<b>Well Name:</b> BIFF	<b>Well Location:</b> T24N / R10W / SEC 20 / NENW / 36.3037554 / -107.9218346	<b>County or Parish/State:</b> SAN JUAN / NM
<b>Well Number:</b> 90S	<b>Type of Well:</b> OTHER	<b>Allottee or Tribe Name:</b>
<b>Lease Number:</b> NMNM43442	<b>Unit or CA Name:</b>	<b>Unit or CA Number:</b>
<b>US Well Number:</b> 300453345400S1	<b>Operator:</b> DUGAN PRODUCTION CORPORATION

**Notice of Intent**

**Type of Action:** Plug and Abandonment

## CONDITIONS OF APPROVAL

**Planned P & A Wellbore Schematic**

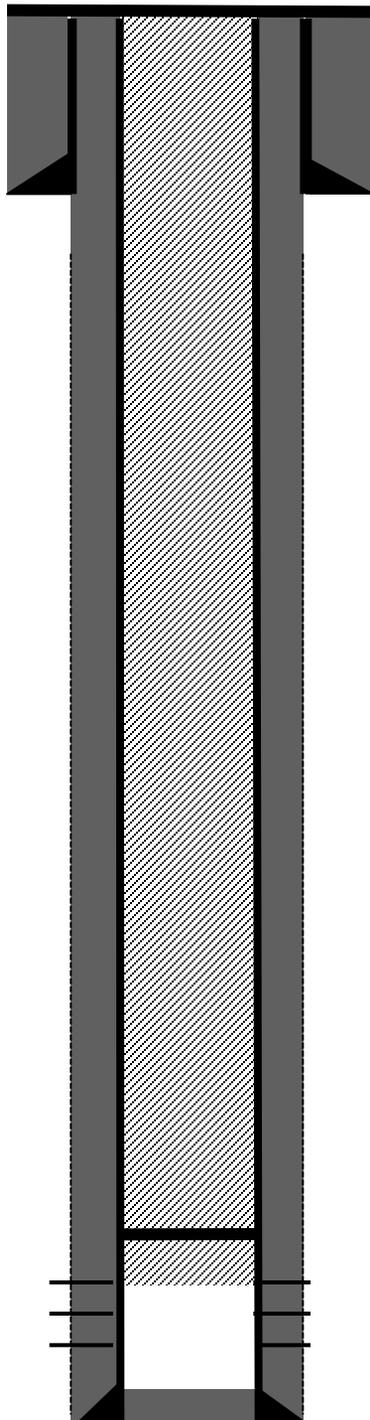
1. Plugging operations authorized are subject to the attached "General Requirements for Permanent Abandonment of Wells on Federal and Indian Lease."
2. The following modifications to your plugging program are to be made:
  - a. Complete wellbore fill up. No changes to the procedure.
3. **Notification:** Farmington Office is to be notified at least 24 hours before the plugging operations commence at (505) 564 7750.

Complete wellbore fill up. No changes to the procedure.
